Addendum 2
Solicitation 21-99268 Fairmount Snowmobile Trails

Re: Amendment No. 2
Fairmount Snowmobile Trail
TKDA Project No. 17426.000

The following items are being modified in the Fairmount Snowmobile Trail plan.

KEENE LARGE SPAN CULVERT - ALT 1 1 of 3

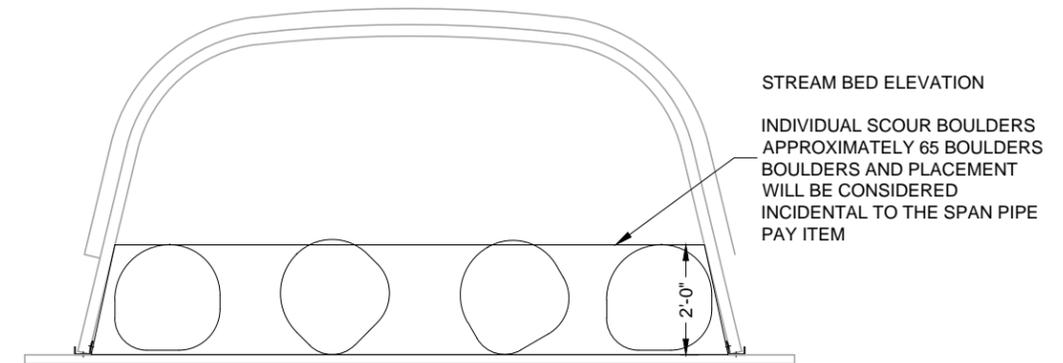
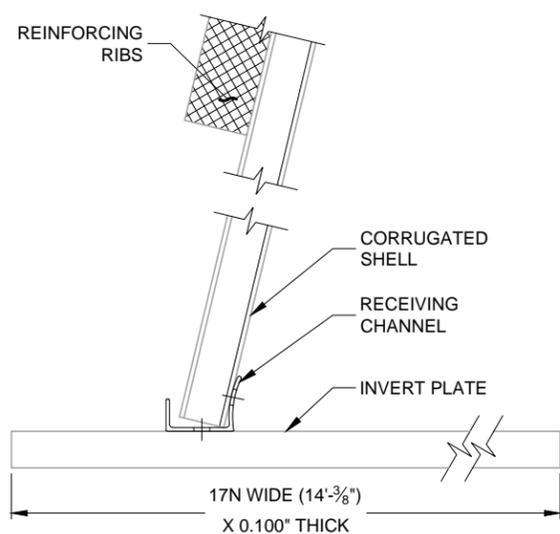
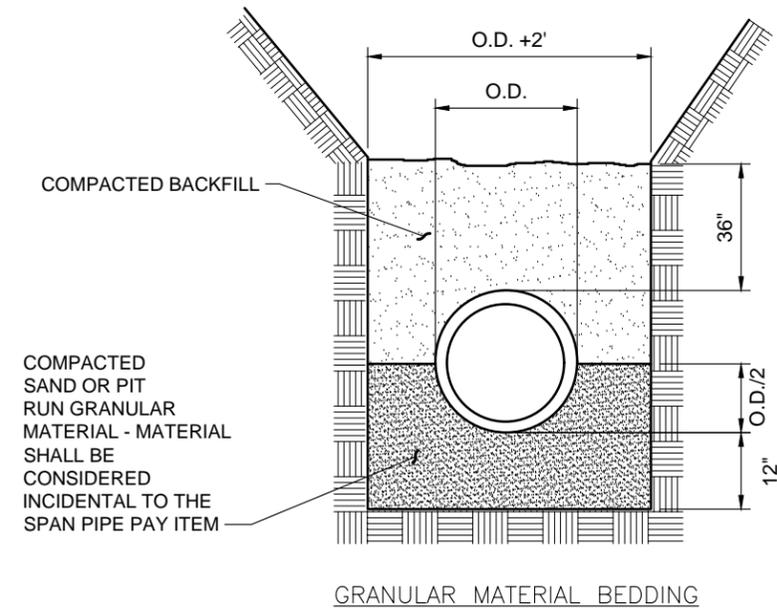
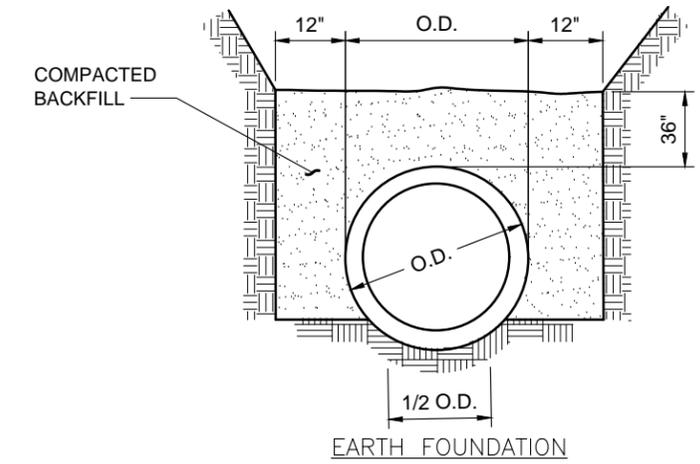
- The large span culvert on the Keene Creek Alternate has been modified to be a closed floor structure with boulders (2' nominal size) placed across the floor. This modification eliminates the buried concrete foundations along the pipe walls.
- This addendum seeks to clarify that Culvert aprons are to be installed on the downstream side of all culverts as part of the base bid. Aprons on the upstream ends will be included in alternate 3.
- Riprap quantities for the trail culverts have been modified.
- This addendum updates the specifications to allow for additional pipe suppliers as long as their product meets the material and performance specifications.
